DEVELOPMENT APPLICATION P867 – PROPOSED ANIMAL HUSBANDRY-INTENSIVE (CATTLE FEEDLOT) AT NO. 144 (LOT 150) PICKLES ROAD, NARRIKUP

A – Development Application P867 B – Public Submissions C – Agency Referral Responses

Meeting Date: 28 October 2025

Cattle Feedlot Concept Plan

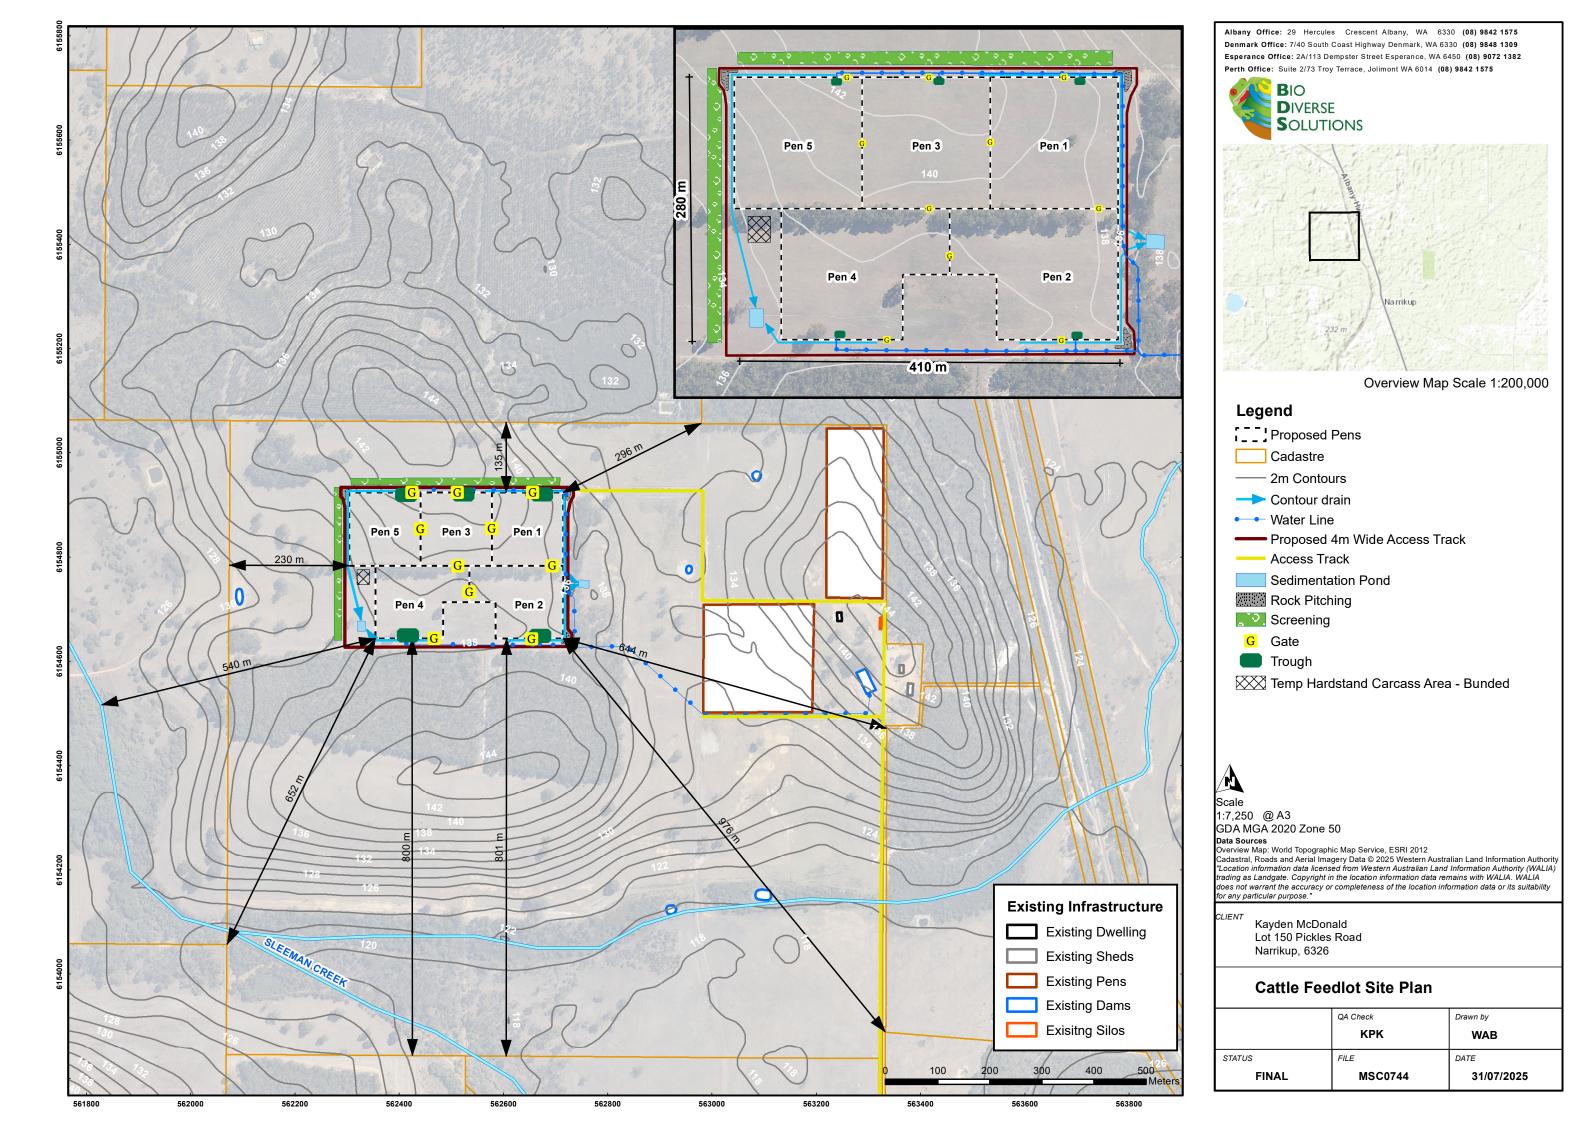
Typically, cattle feedlots use a system of sedimentation drains and holding ponds to manage runoff. While these attributes are marked on the site plan, there is insufficient information regarding construction and capacity of the proposed system.

The proponent is required to provide adequate details of the proposed runoff system infrastructure to allow it to be assessed for adequacy against the Guidelines and Code of Practice. The proponent should address design features such as capacity and velocities, construction details of materials and access, and management details such as monitoring and risk assessment.
